Amendments to the Drawings:

Attachment: Annotated Sheets Showing Changes

REMARKS/ARGUMENTS

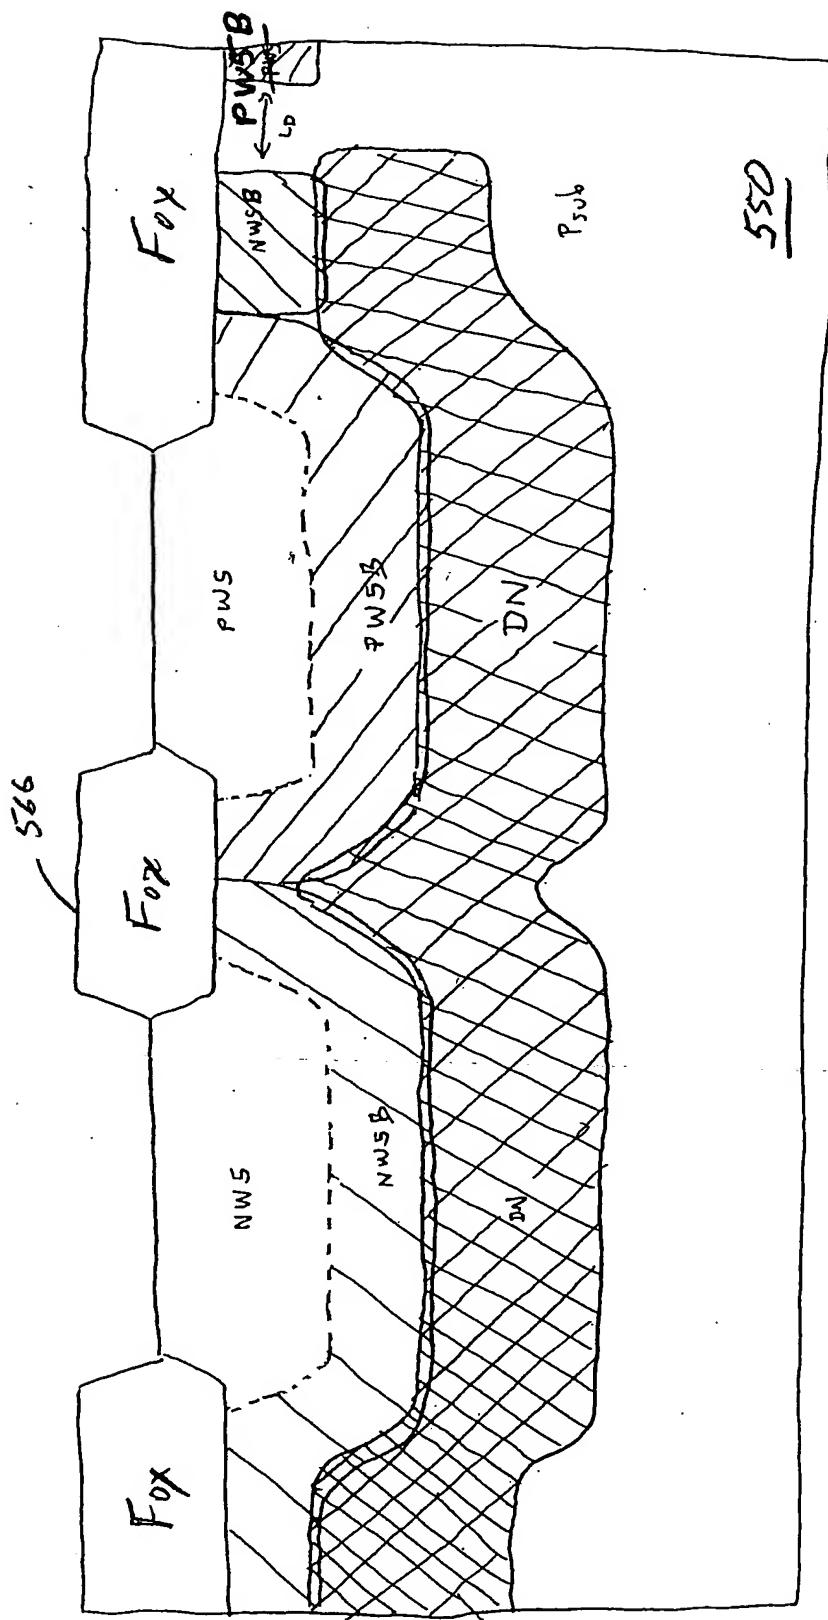
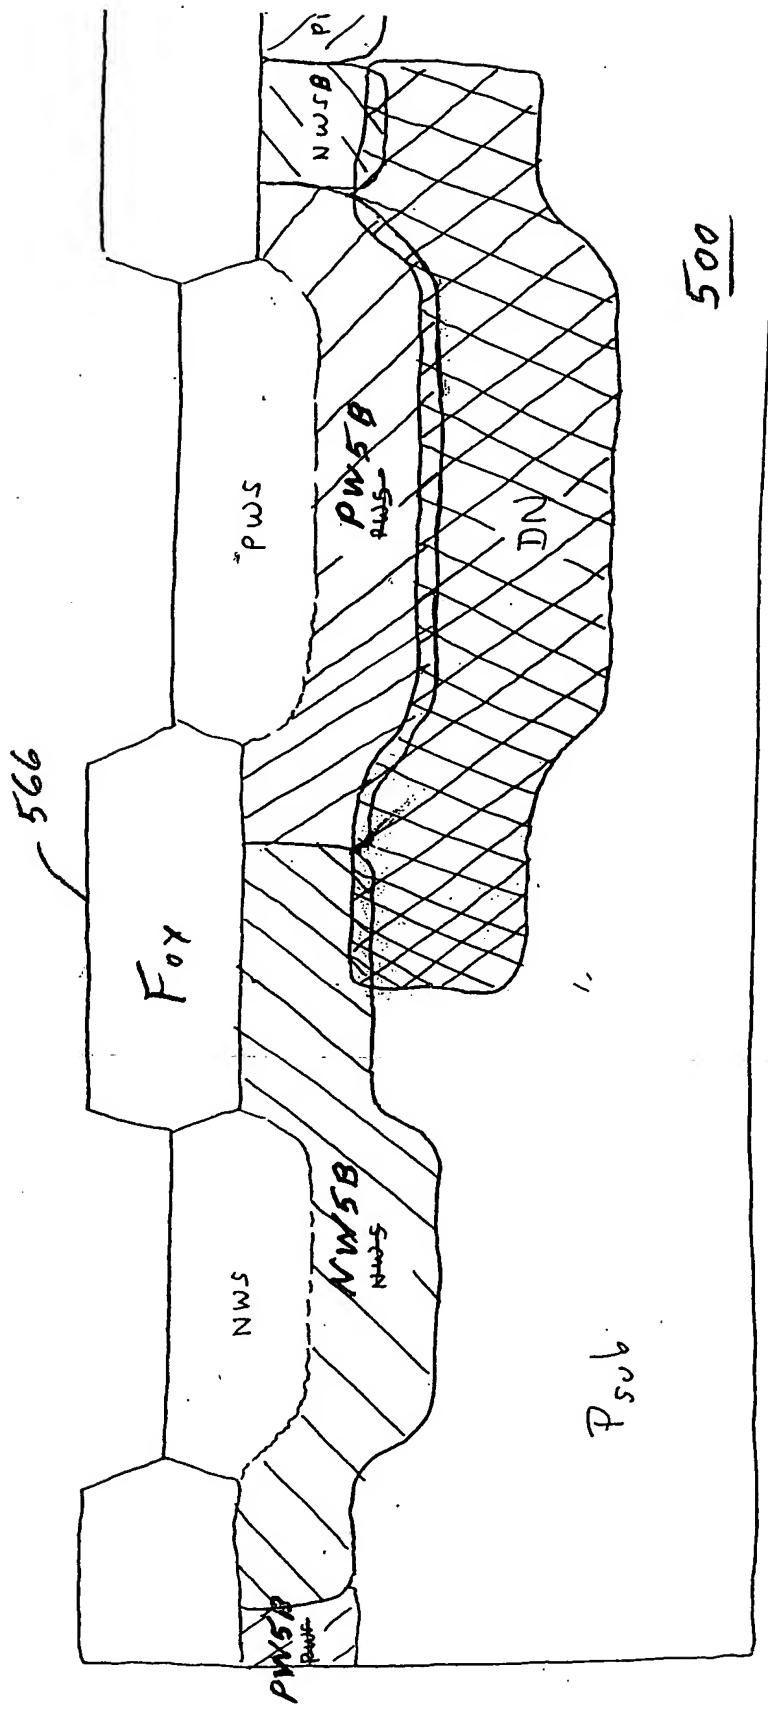
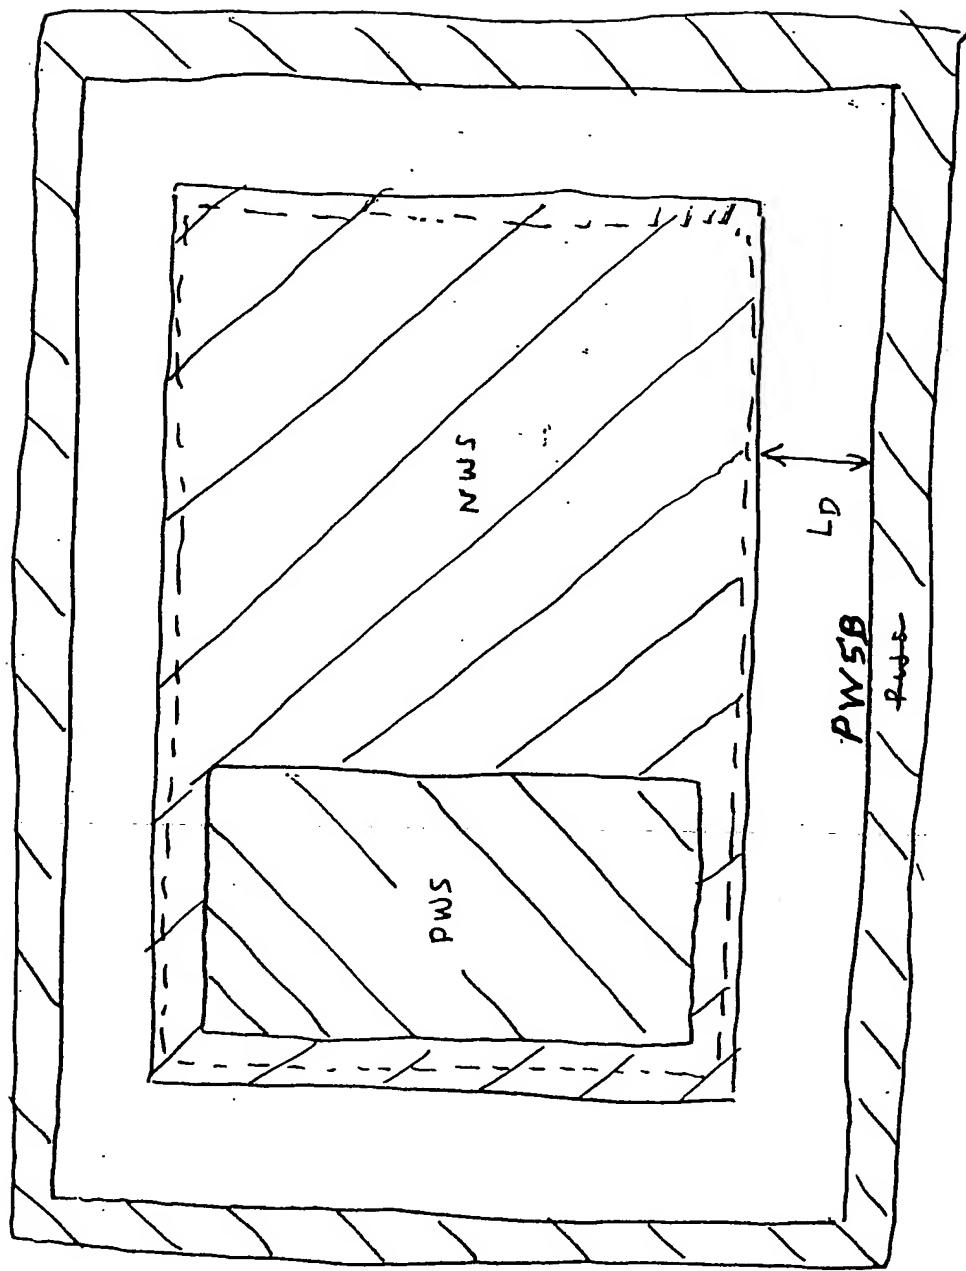
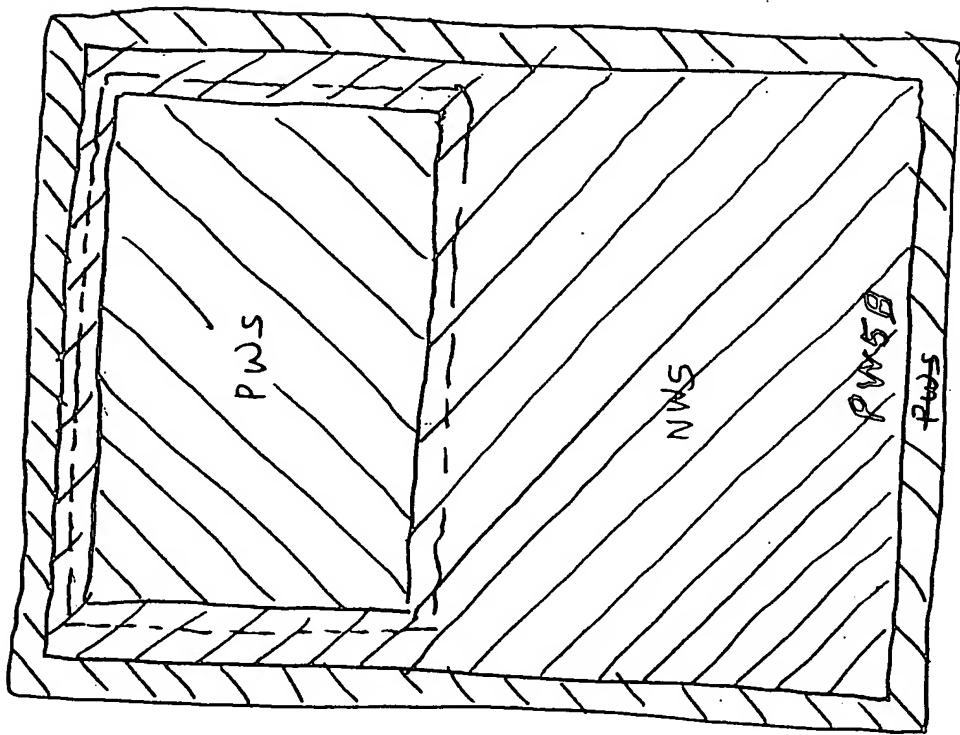
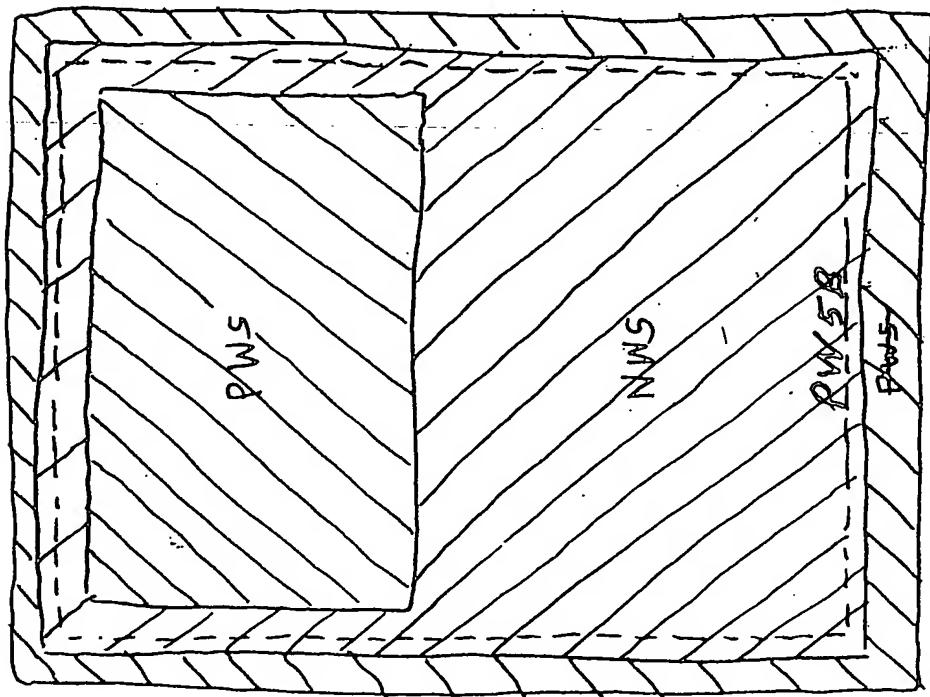
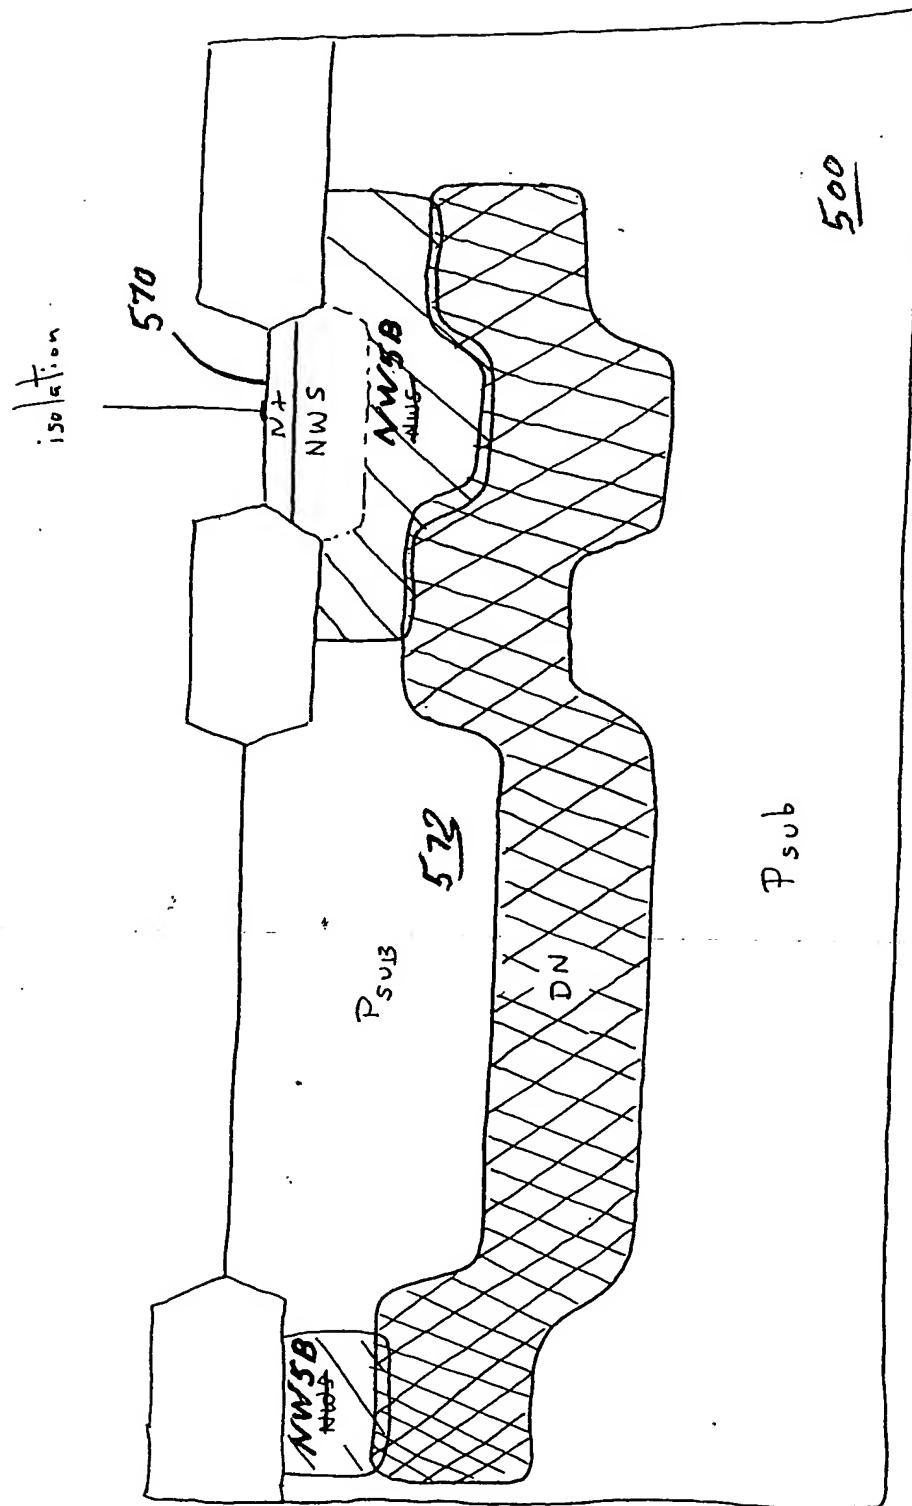
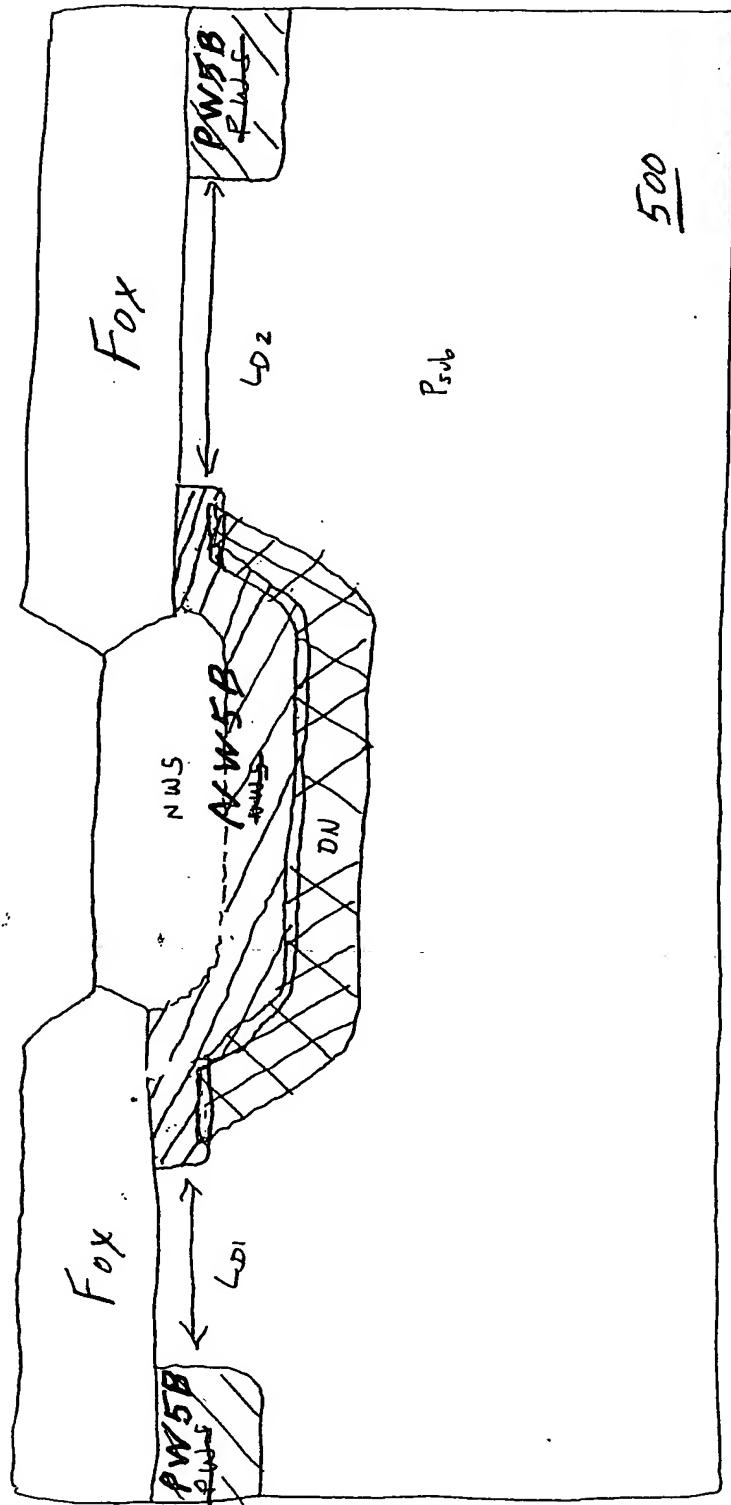
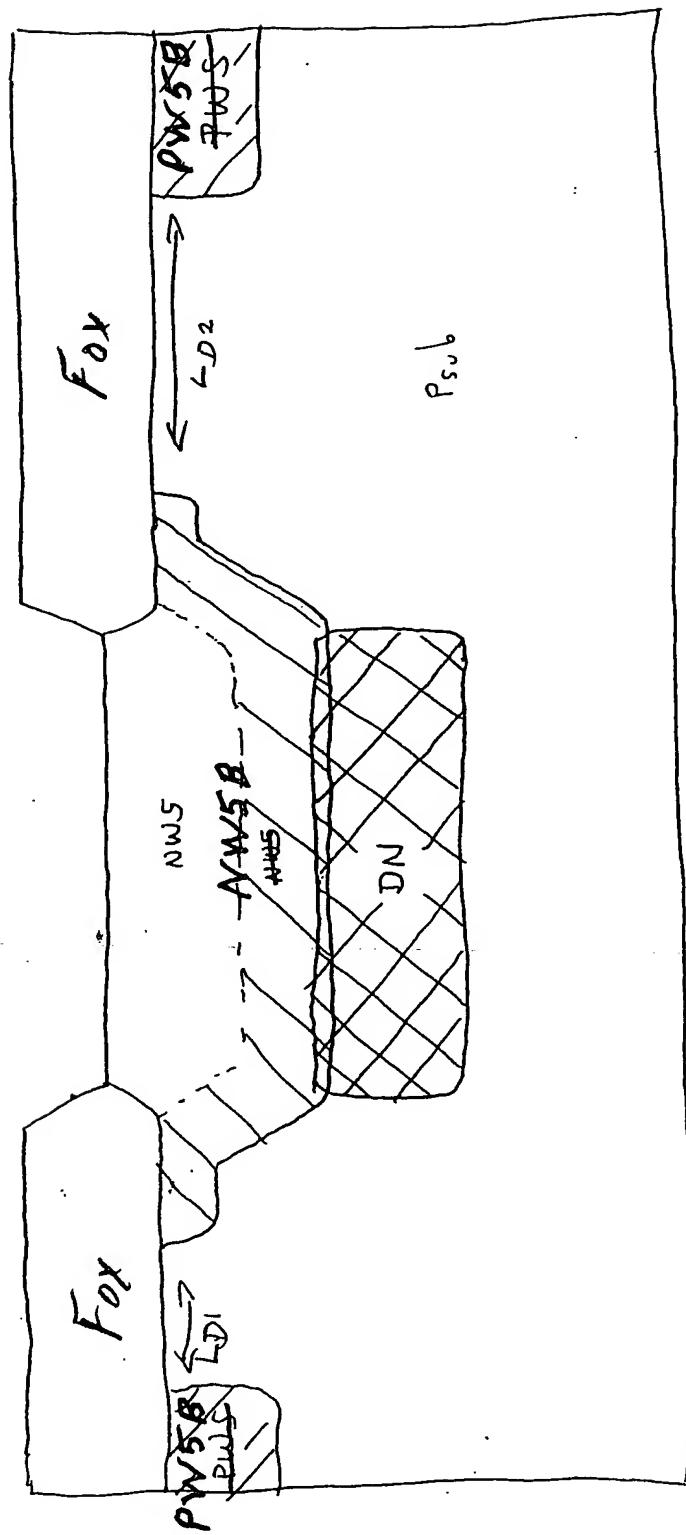
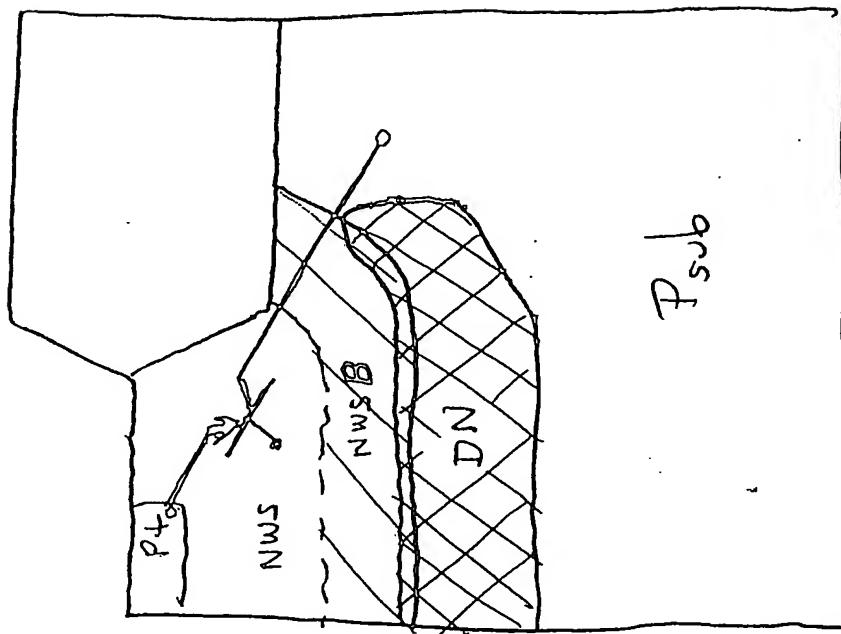
In Figs. 14A-14E, 14H-14P, 15A, 16A, 16B, 16D and 16F, in a number of instances the reference numeral PW5 has been changed to PW5B, the reference numeral NW5 has been changed to NW5B, the reference numeral PW12 has been changed to PW12B, and the reference numeral NW12 has been changed to NW12B, as shown on the enclosed Annotated Sheets. These changes are clearly supported, for example, at page 36, lines 14-17, of the substitute specification filed February 18, 2004, where it is indicated that the suffix "B" is used to denote an implanted layer of dopant as opposed to a "well" of dopant. In any event, these changes are merely changes in labeling and as such do not constitute new matter.
